2008 Interim Design Standard

ALUMINUM PEDESTRIAN/BICYCLE PICKET RAILING

Interim Date	Sheet No.
01/01/08	1 of 5
Index No.	
860

DETAIL FOR NON-CONTINUOUS RAILING AT CORNERS

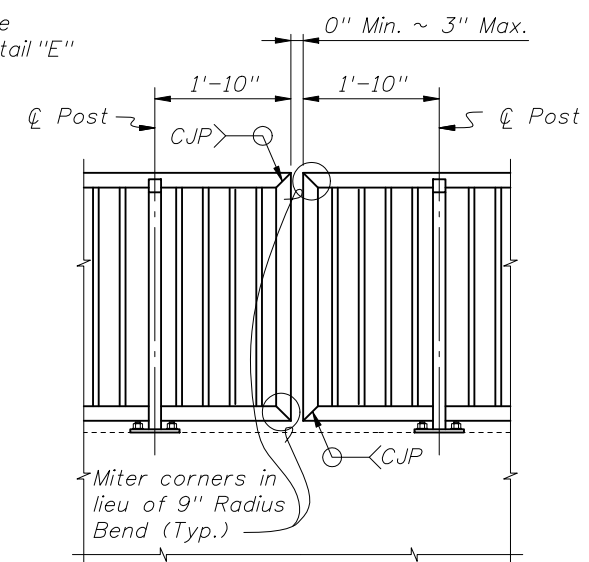
REVISIONS			
DATE	BY	DESCRIPTION	
01/01/08	SJN	Added "DETAIL FOR NON-CONTINUOUS RAILING AT CORNERS" detail. Changed Pedestrian and Bicycle Railing designations, and maximum ramp lengths.

DETAIL "D" - EXPANSION JOINT
(FIELD SPLICE SLIP JOINT SIMILAR)

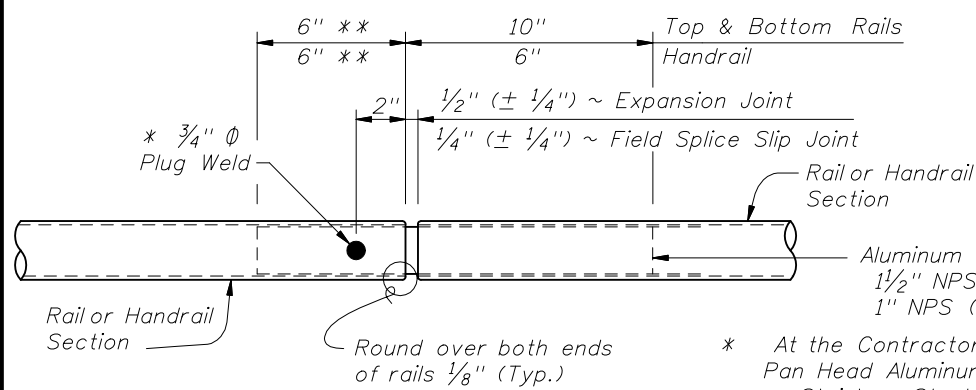
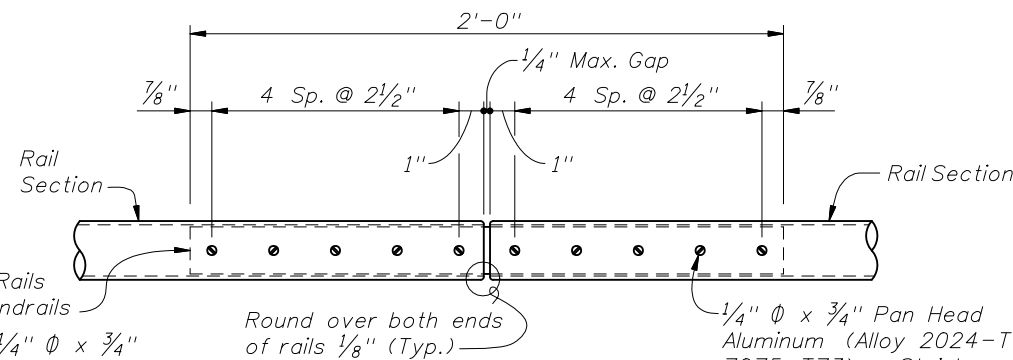
DATE	BY	DESCRIPTION	DATE	BY	DESCRIPTION
01/01/08	SUN	Added requirement for set screw to be set flush against outside face of rail, 18-8 Alloy option in DETAILS "D" & "E" and TYPE B (NONWELDED) Detail, and 1/4 inch joint tolerance in Detail "D".			Changed 1'-0" embedment of Rail Expansion Joint Sleeve to 10".

DETAIL "F" (OPTIONAL SHIMMING DETAIL FOR CROSS SLOPE CORRECTION) (Used in lieu of Beveled Shim Plates)

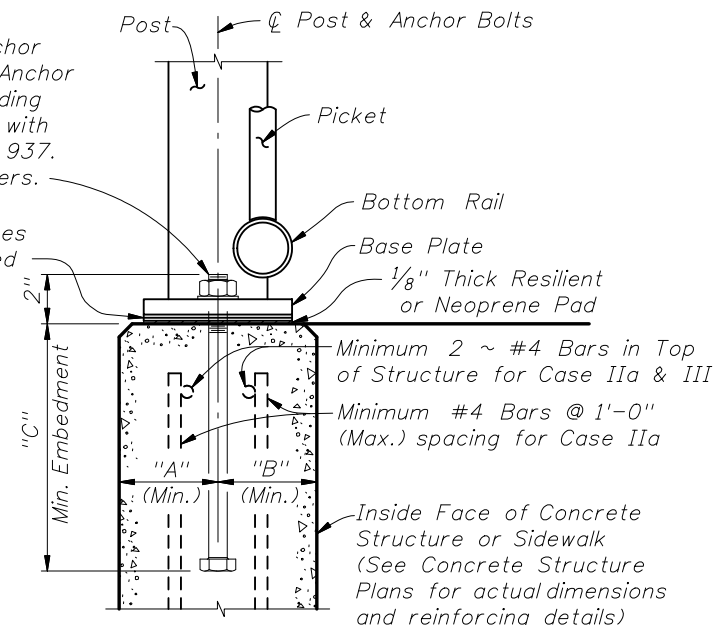
DATE	BY	DESCRIPTION	DATE	BY	DESCRIPTION
01/01/08	SJN	Added "DETAIL "F" (OPTIONAL SHIMMING DETAIL FOR CROSS SLOPE CORRECTION)", and note (*) to ANCHOR BOLT TABLE. Changed Pedestrian and Bicycle Railing designations. Corrected height on step to top of nosing.
